DEVELOPMENT/ PLAN REVIEW APPLICATION

TO: John Griego FAX #: 438-0028
FROM: Russell Brito Contact Phone #: 924-3337
RE: **Site Development Plan for Building Permit Deficiencies**
Project Description: Family Worship Center
EPC Project #: 1000694 EPC Case #: 03EPC-01111

TO: SHERAN MATSON, DRB CHAIR
FROM: MARY PISCITELLI, STAFF PLANNER
SUBJECT: FAMILY WORSHIP CENTER, PROJECT #1000694
DATE: 11/26/03
CC: JOHN GRIEGO, JCG ARCHITECTS

JOHN GRIEGO agent for FAMILY WORSHIP CENTER request the above action for all or a portion of Lot 226, 227 228, 229 and 230 **Town of Atrisco Grant -Airport Unit**, zoned SU-1 Church, located on GLENRIO NW, between 72ND ST. NW and I-40, containing approximately 8 acre(s). (J-10) Mary Piscitelli, Staff Planner

LANDSCAPE PLAN

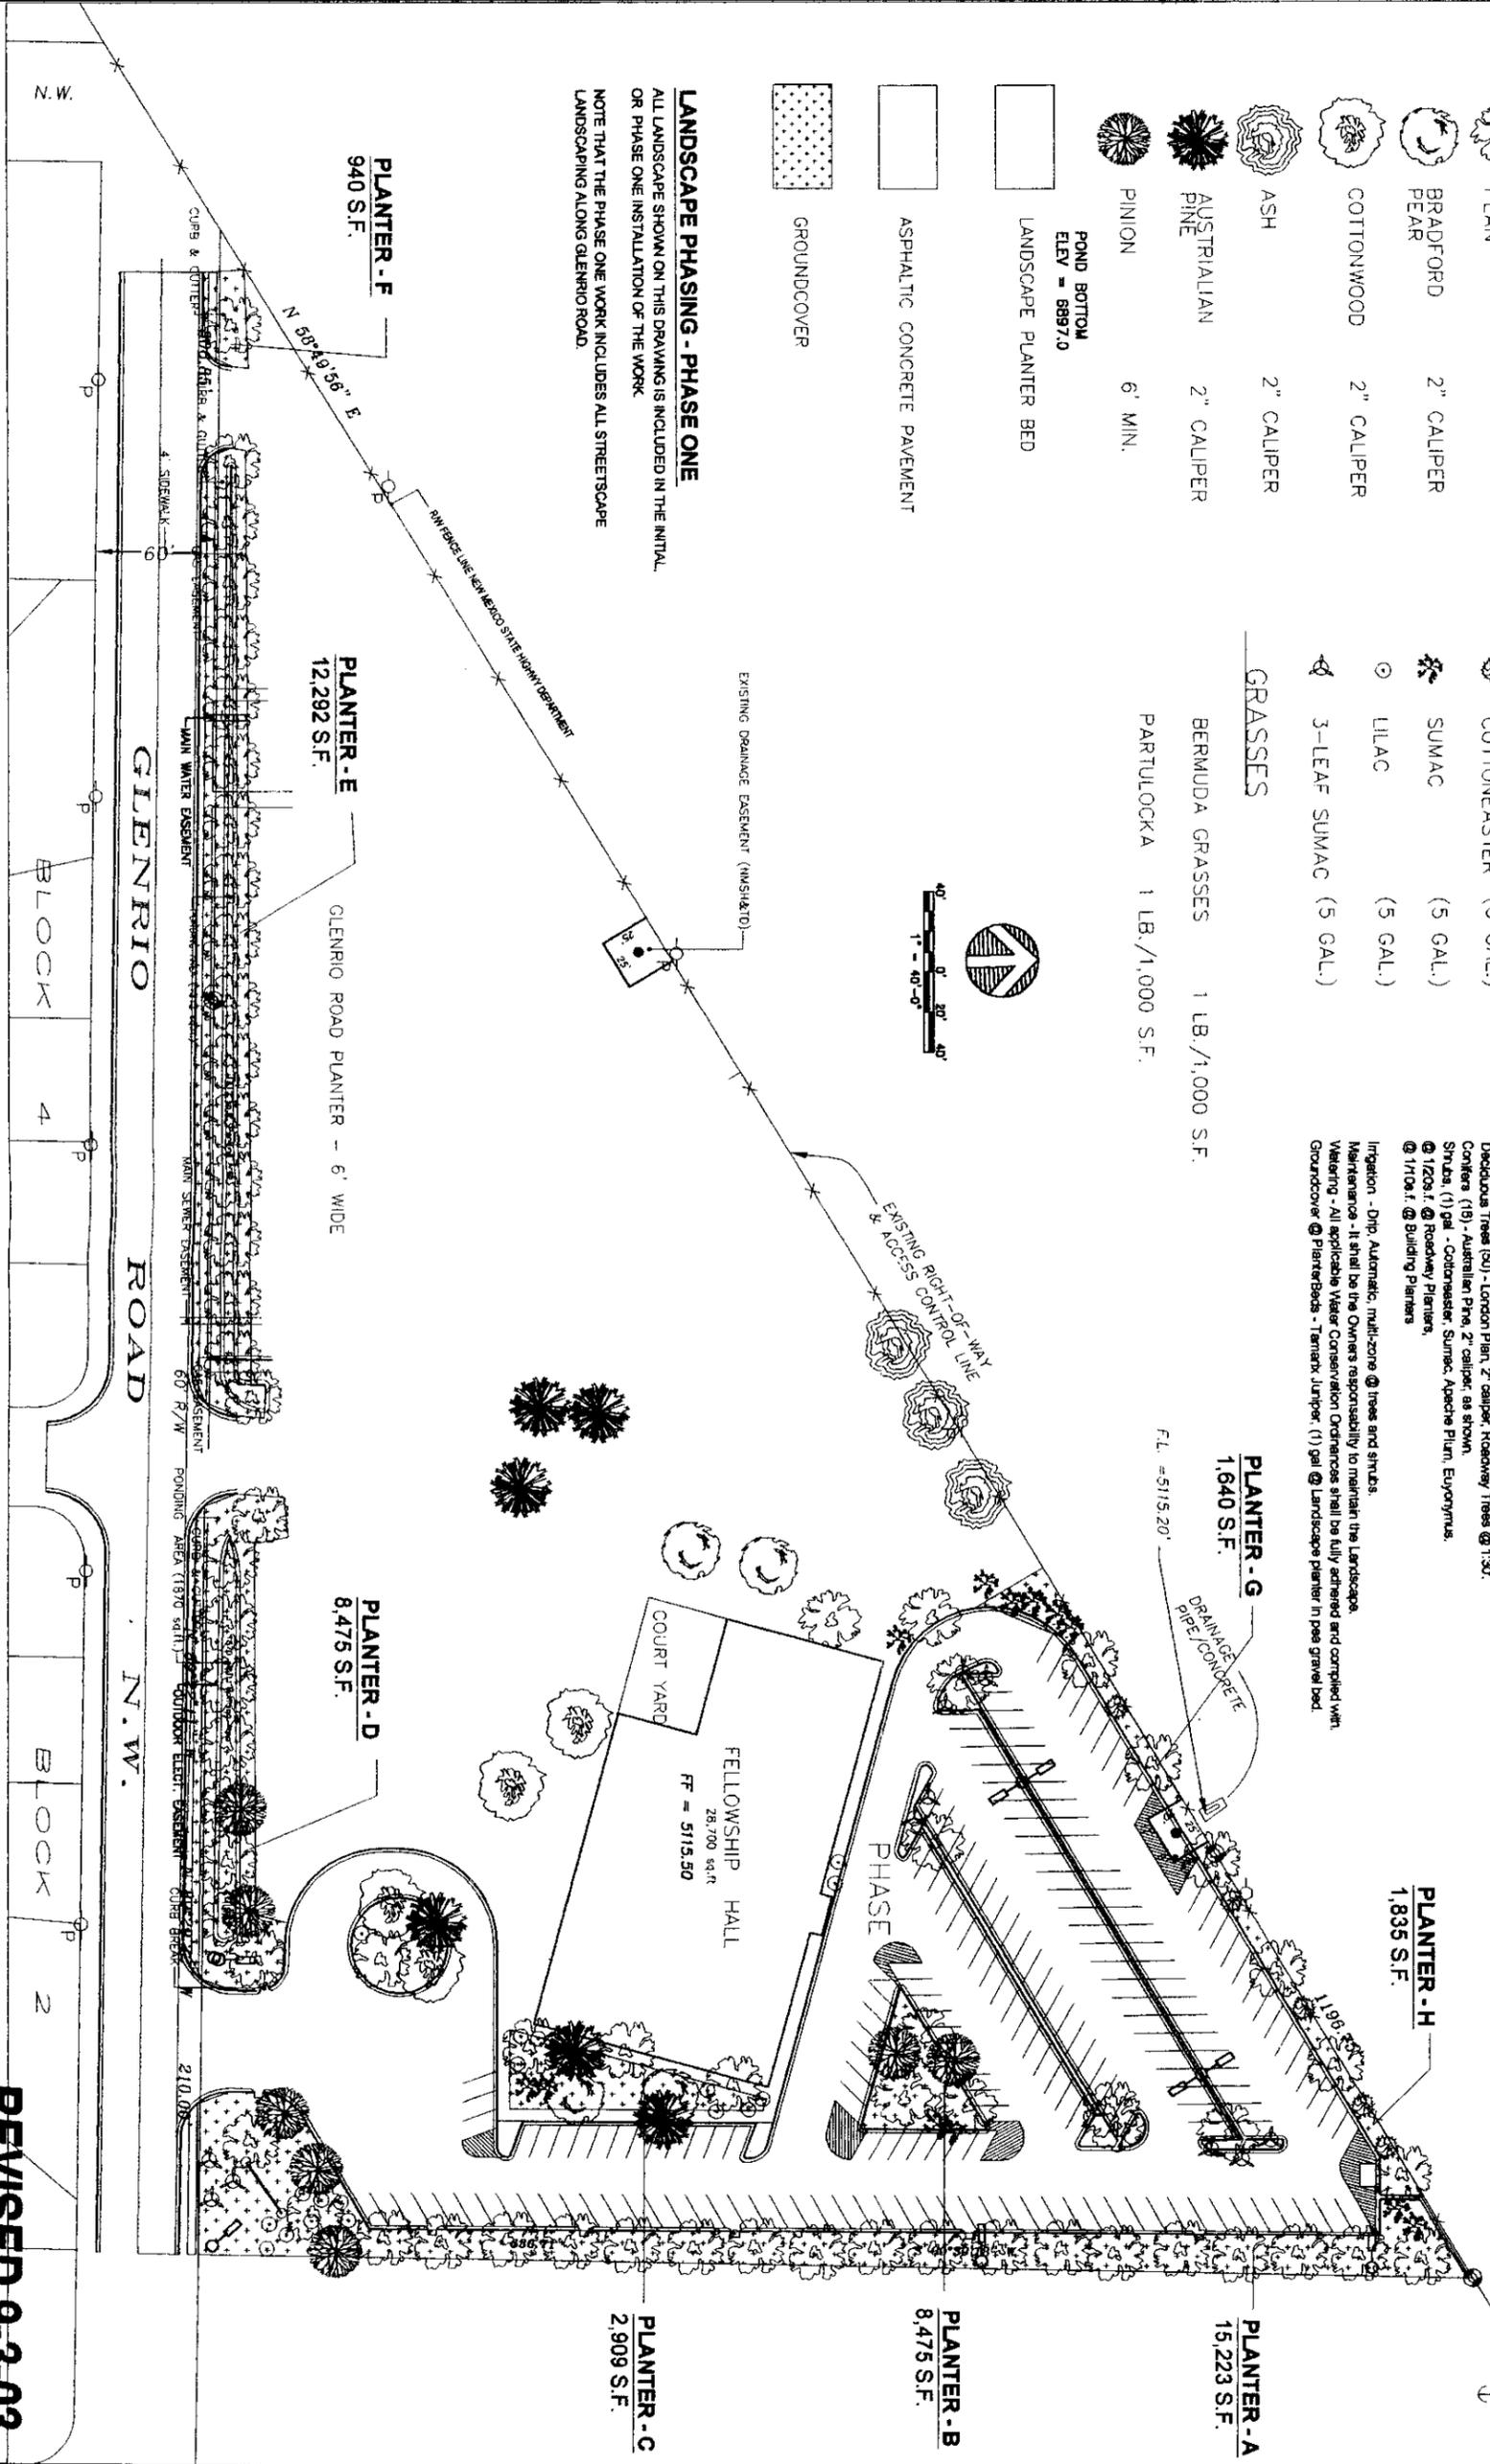
- p. L-1. The landscape plan shows the building area as 21,148 sf. The master plan for the site shows the same building area as 28,000 sf. This discrepancy will need to be addressed, because their landscaping calculations are affected by the difference of approximately 7000 sf of building.

Sheet 5 – L-1 LANDSCAPE PLAN
